**PARK CITY PLANNING COMMISSION MEETING
SUMMIT COUNTY, UTAH
January 24, 2024**

Planning Commission Staff Report

Subject: 220 King Road Plat Amendment, Conditional Use Permit, and Steep Slope Conditional Use Permit
Applications: PL-22-05318 (Plat), PL-22-05319 (CUP), & PL-23-05571 (SSCUP)
Authors: Alexandra Ananth, Senior Planner
Caitlyn Tubbs, Historic Preservation Senior Planner
Date: January 24, 2024
Type of Item: Work Session

Figure 6: Footprint area as calculated by the Planning Department outlined in red. This image is from a 2022 submittal and may not be the most recent floor plan. No floor plans were submitted with the December 29, 2023, submittal.

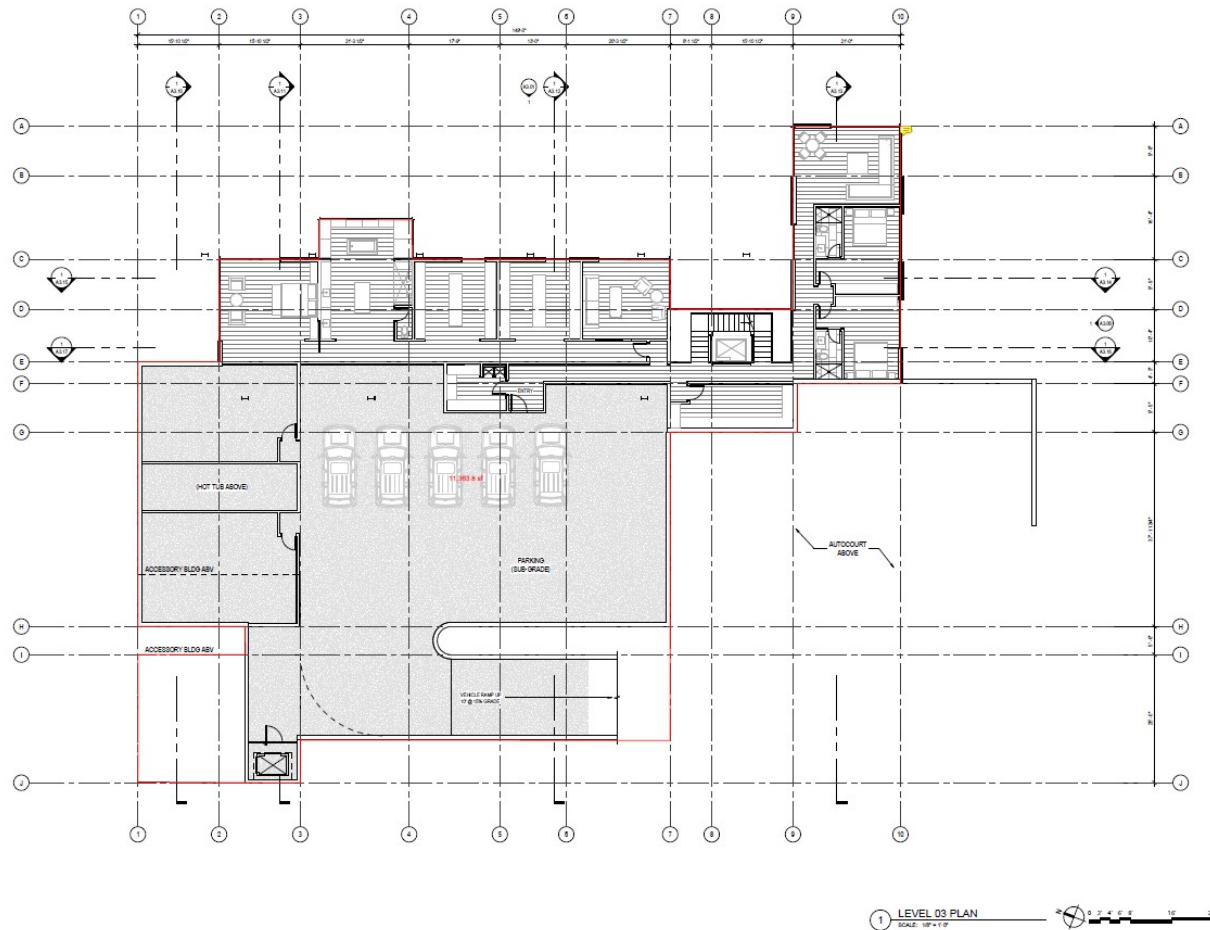
The Planning Department is concerned that the proposed amendments promote sub-grade development inconsistent with the MPD's intent to limit the Building Footprint to 3,500 square feet, Building Height to 30 feet, Building Area Limits, or visual impact of development on the Historic District. However, the Applicant contends there are not

The Applicant also calculates the Building Footprint at the lowest level, which has the smallest Footprint at 3,475 square feet. However, the structure cantilevers beyond this footprint, greatly increasing the mass of the structure and the amount of excavation required, and thus should be considered by the Planning Commission.

The current LMC definition for Building Footprint uses the furthest exterior wall of the Structure projected to Natural Grade. The Planning Department calculates the Applicant's actual building footprint at approximately 11,300 square feet, using the LMC definition's methodology.

Figure 8: Proposed Building Area Limits with Sensitive Land Overlay shown in red.

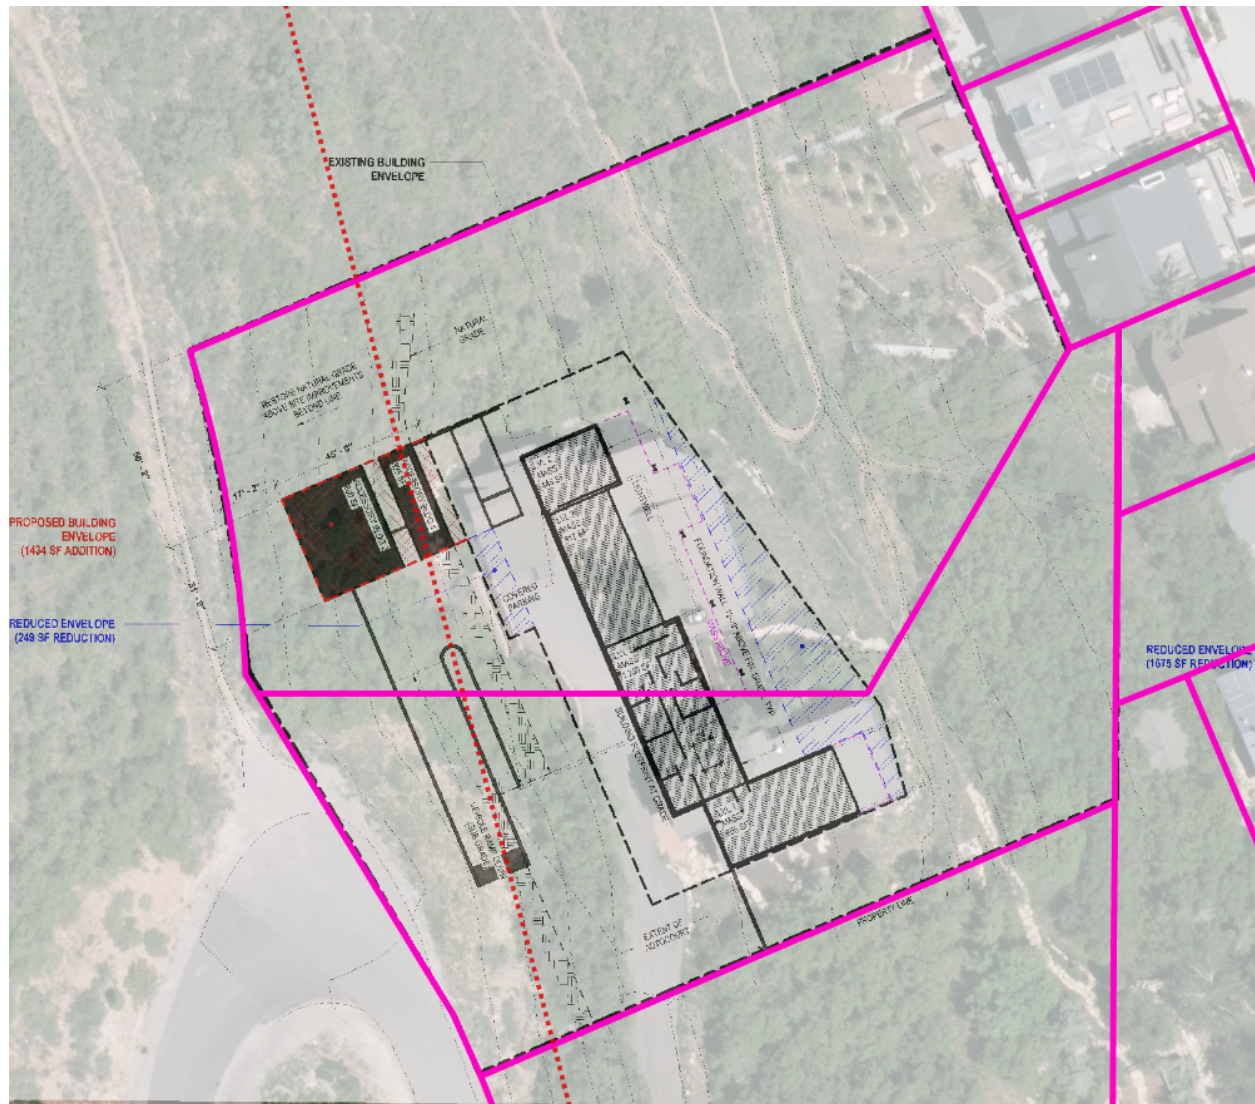
Currently the Building Area Limits are not in the SLO. The Applicant is proposing to shift the platted Building Area Limits uphill, and portions of the structure and Building Area Limits would be in the SLO as shown below. As a result, we seek Planning Commission clarification after discussing directly with the Applicant.
